UNITED STATES
NUCLEAR REGULATORY COMMISSION
WASHINGTON, D. C. 20565

Docket Nos: 50-424 and 50-425

FACILITY: Vogtle Electric Generating Plant, Units 1 and 2

SUBJECT: SUMMARY OF NOVEMBER 14, 1991, MEETING REGARDING
SUBSTITUTION OF FORGED FITTINGS

FIGURE 1

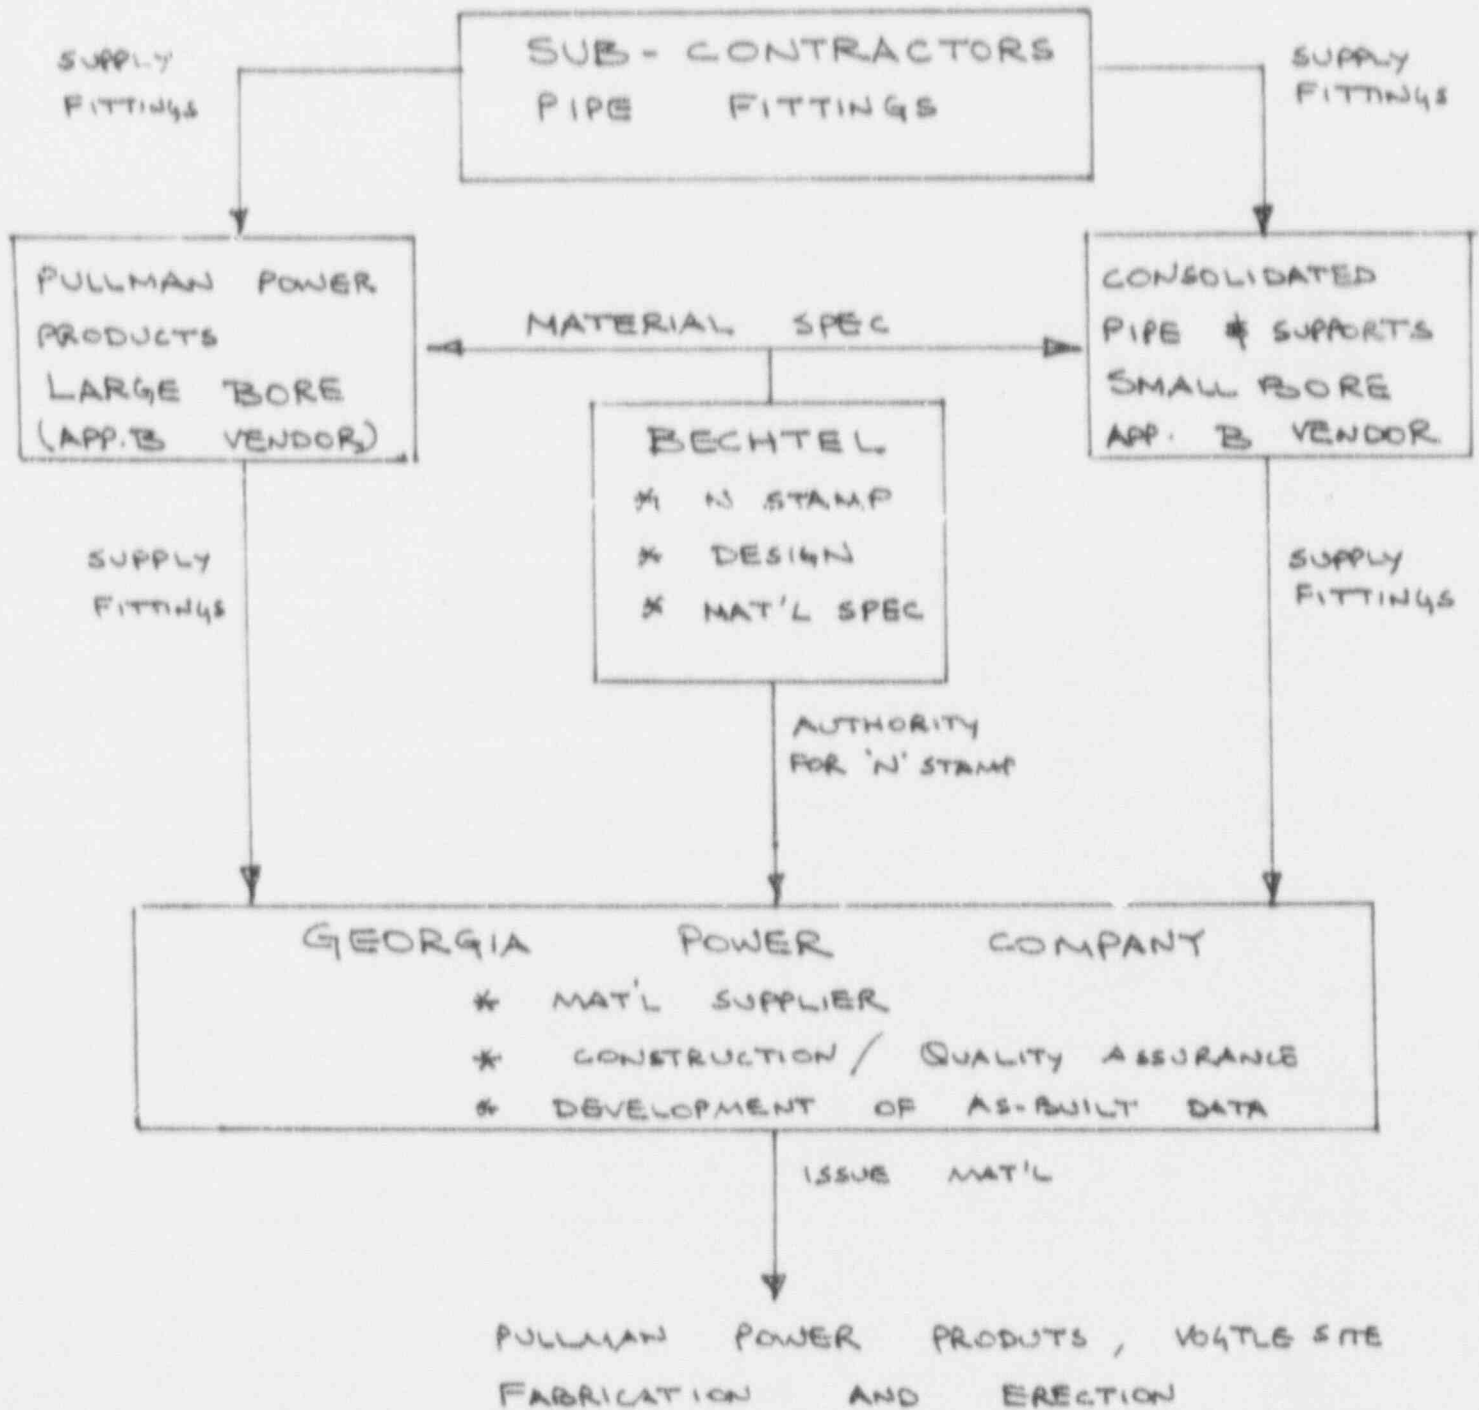
Mr. W. Ramsey of GPC discussed GPC's discovery and subsequent evaluation of the issue (Enclosure 2). He also reviewed the structure and responsibilities of various organizations which existed during the design and construction phase of Vogtle Unit 2 (see Figure 1).

Geometrical Comparison

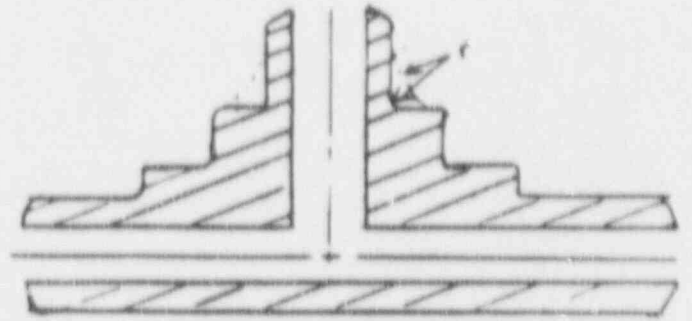
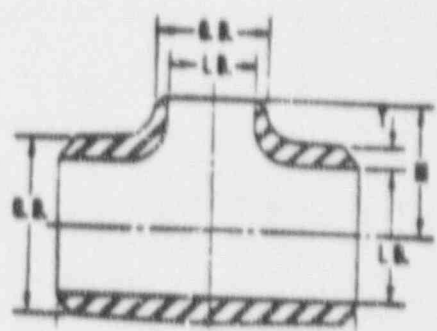
After GPC's and Westinghouse's presentation, the NRC staff asked why the substitution of the forged fittings had not been discovered during any of three distinctive phases of construction of the plant, namely: 1) material receipt inspection, 2) development of the walkdown of as-built data for stress reconciliation, and 3) design reconciliation of the as-built data with the stress analyses. GPC indicated that the piping vendor's QA program and ANI certification programmatically ensured compliance with the specifications for piping fabrication and installation. Therefore, GPC's receipt inspection only confirmed that the fittings were certified by the ANI. GPC also stated that its walkdown procedures for development of as-built data did not include verification of the type of tees installed. Additionally, GPC indicated that the as-built walkdown was not performed by stress engineers but was performed by QA personnel who could not be expected to recognize that forged tees had been substituted for extruded tees. Consequently, the walkdown data did not identify the forged fittings, and the stress engineers performing the stress analysis reconciliation were not aware of the existence of forged fittings.

1. Typical dimensions of extruded, and block and die forged tees,
2. Pullman Power Product Corporation letters dated May 29, 1987, and May 24, 1990,
3. Westinghouse letter V-SAMU-10660 dated January 26, 1989,
4. Westinghouse memorandum GTSD-VFDV-4528 dated October 3, 1986, including "As-Built Engineering Walkdown Guidelines, Phases 1 and 2,"
5. Vogtle finalization program attached to memo 2X7BD80-FP7 dated October 7, 1987,
6. Project Reference Manual, Section 17, "Final Design Verification for Safety-Related Piping Systems,"
7. Westinghouse design specification 955211, and
8. Westinghouse Analysis Packages for as-built reconciliation.
